P802.1AB/D2

Changes, Recommendations, and Discussion items

Bill Lane
CSU, Chico
January, 2003

Figure 6.1 Architectural positioning of LLDP

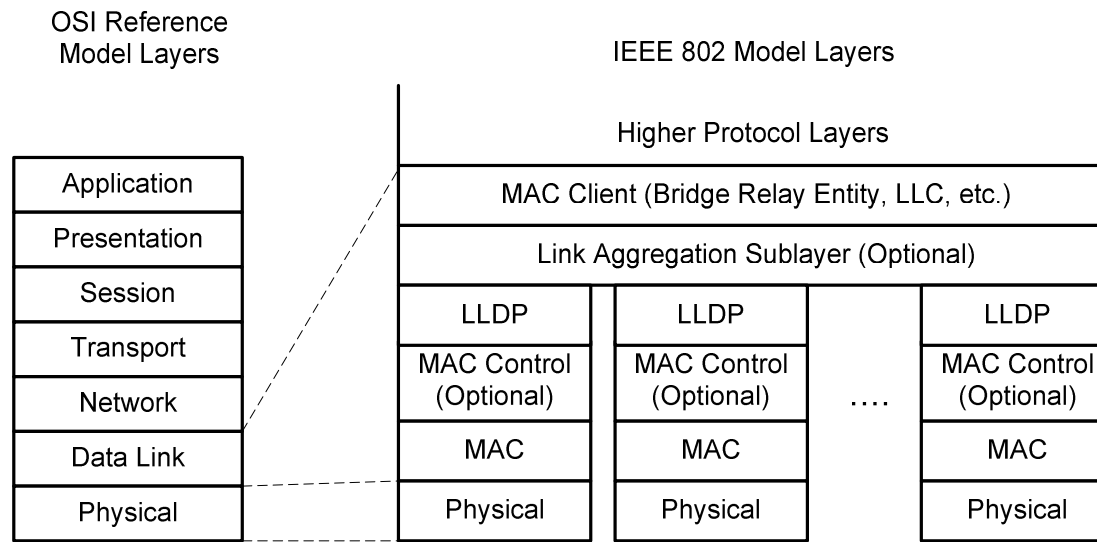
- Revised figure 6.1 to show LLDP over individual port MACs but below link aggregation.

Figure 7.1 LLDP frame multiplexing

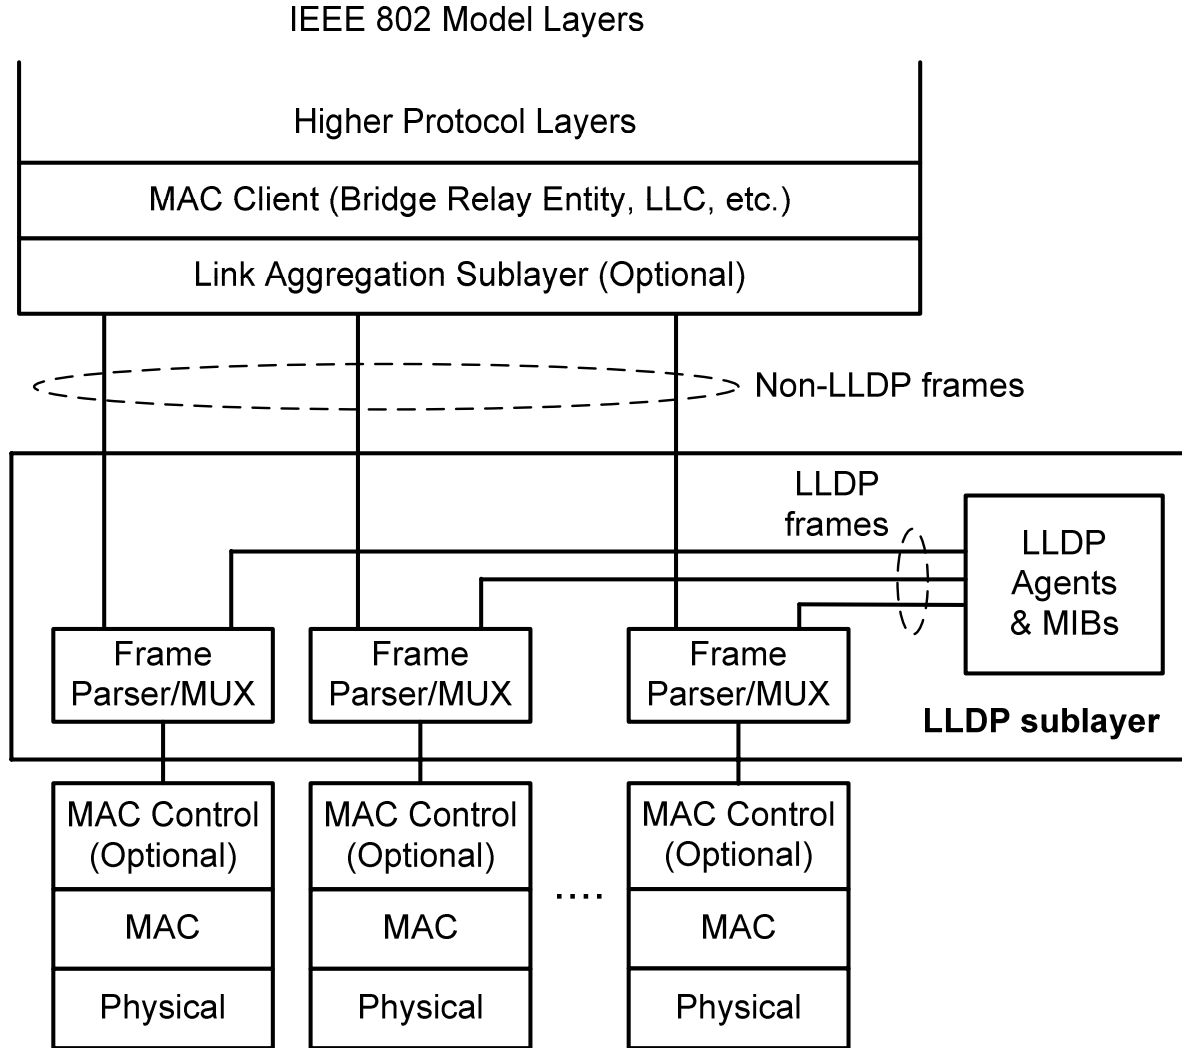
- Added new figure 7.1 showing parser/MUX
- Renumbered and revised figure 7.2 (old 7.1), the protocol block diagram
- Expanded the text description of LLDP operation.

Figure 8.1 802.3-based LLDP frame format

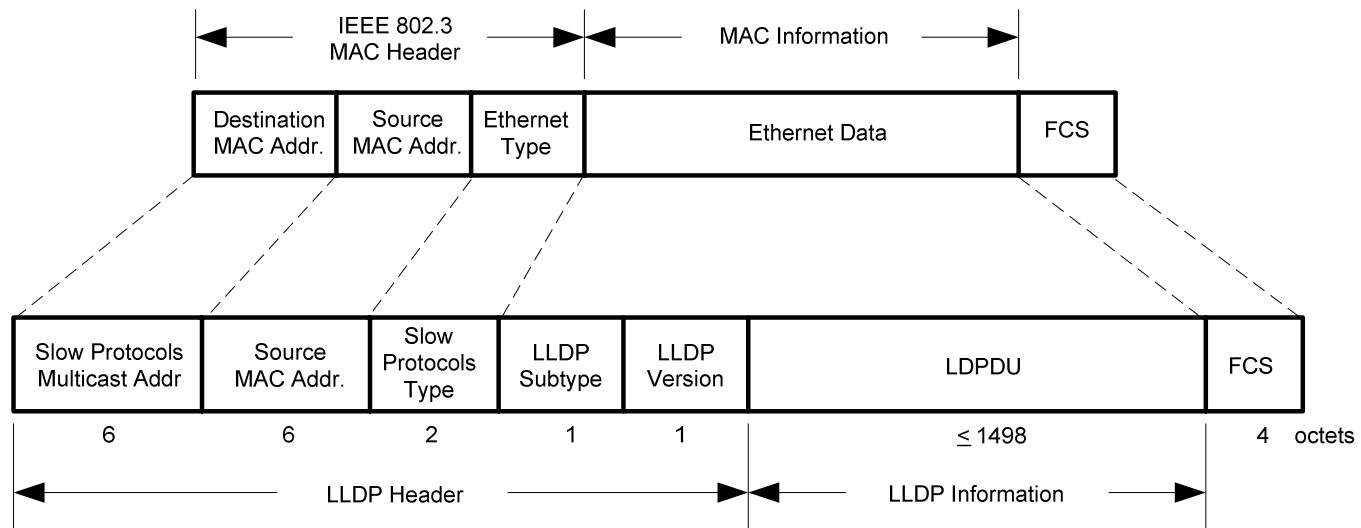
- Changed all figures from vertical to horizontal format.
- Added Ethertype SNAP-encoded format for Token-Ring use.
- Changed management address TLV from mandatory to optional.
- Added details for specific TLVs that were missing in D1.
- Revised subclause numbering to ensure that each TLV could be listed in the table of contents.

Figure 8.3 LDPDU header

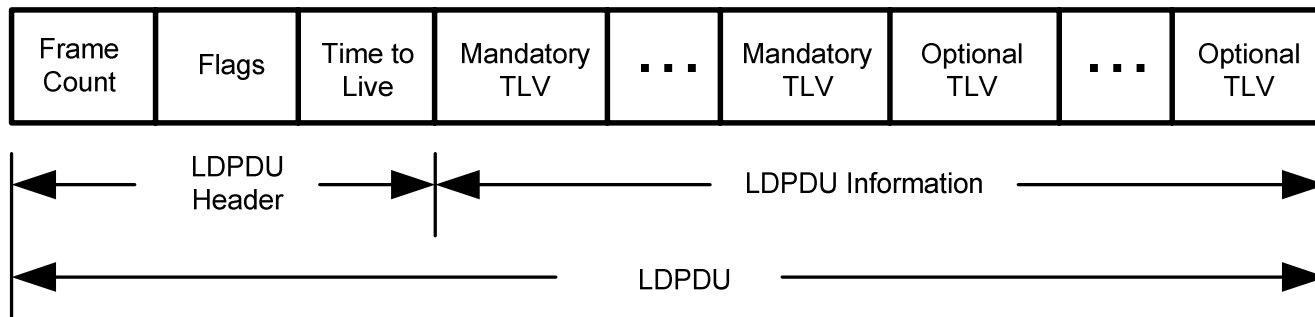
- Added a two digit, 1-octet frame-count field (frame # of total #) to the LDPDU header to ensure that a sequence is complete before MIB update.

Note: this limits the total number of frames in a sequence to 15
